DATE:

July 18, 2001

Residential and Commercial On-site Sewage Systems and

Recessional Moraines in Northeastern Indiana Update to Memorandum of June 19, 2001

Flow Chart for Evaluation of Recessional Moraine Soils for On-Site Sewage System The Modified Soil Permeability Test for Recessional Moraine Soils

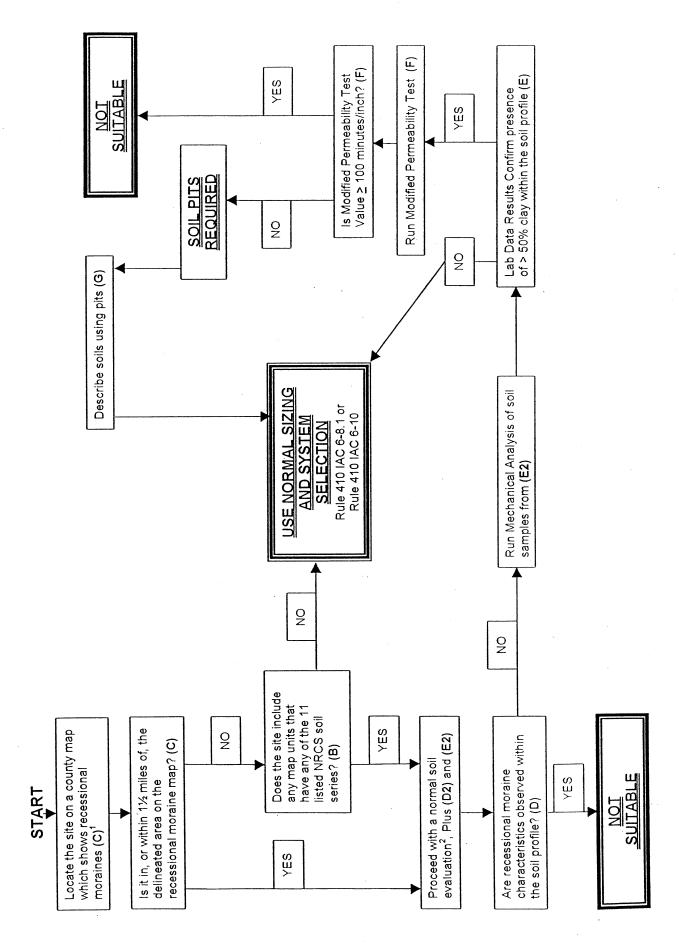
- The implementation of a new procedural flow chart. This revision is due to a question of application of the procedure outside of the moraine soils and the 1 1/2 mile buffer zone. The procedure is to be applied to the soil map units when the site is outside of the recessional moraine and the 1 1/2 mile buffer zone. A new flow chart is attached to reflect that requirement. Please replace the previous flow chart with this one.
